S106 Part 1 'Application to connect to a public sewer' Approval Notice

United Utilities Reference Number:	**09570034**
Applicant details	
Applicant name	Erin Thomas
Applicant address *(including postcode)*	Design and Management Consultants 710 Mandarin Court WA1 1GG
Applicant email	Erin.Thomas@DAM-Consultants.com
Site details: The site / property which is proposed for connection to the public sewer	
Site address *(including postcode)*	The Park Pub, Moorcroft Road, Wythenshawe, Manchester, M23 0AF

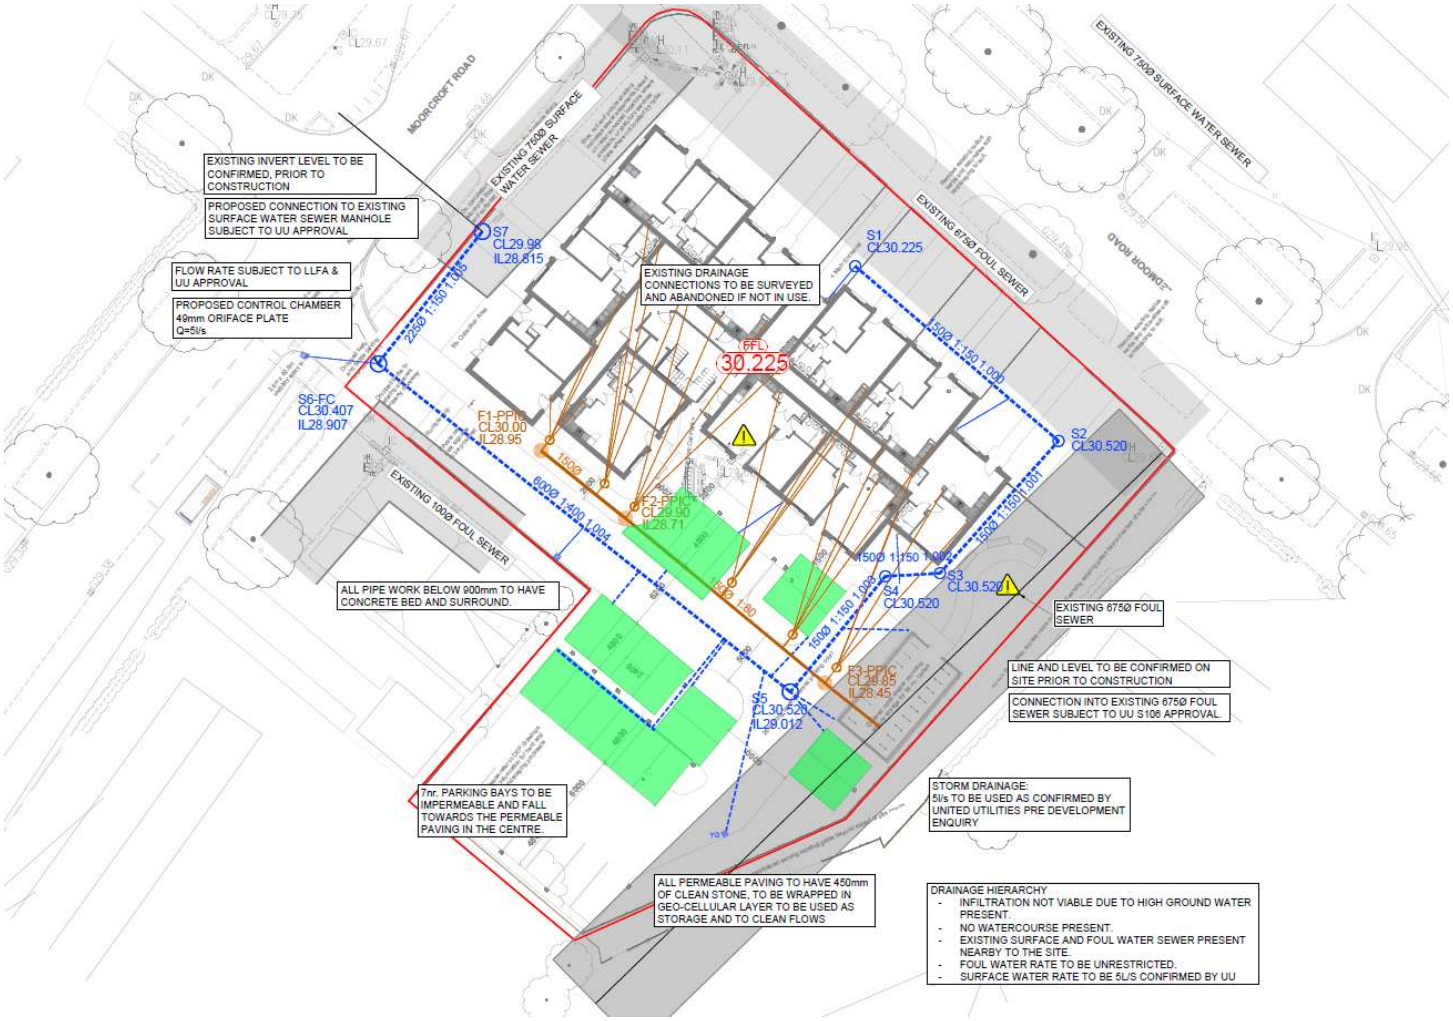
Approval granted for a 150mm foul connection to the existing 675mm combined sewer to the Southeast of the site via a saddle connection

Approval granted for a 225 mm surface water connection to the existing 750 mm surface water sewer crossing Moorcroft Road via an existing UUMH.
The manhole reference is not indicated on the drainage plan; however, it appears to correspond to MH6208 on the sewer records.
With a flow control restricted to 5l/s
Please ensure that sufficient investigations are undertaken to confirm that this manhole can accommodate the proposed connection. A manhole drawing will also be required as part of your Part 2 application
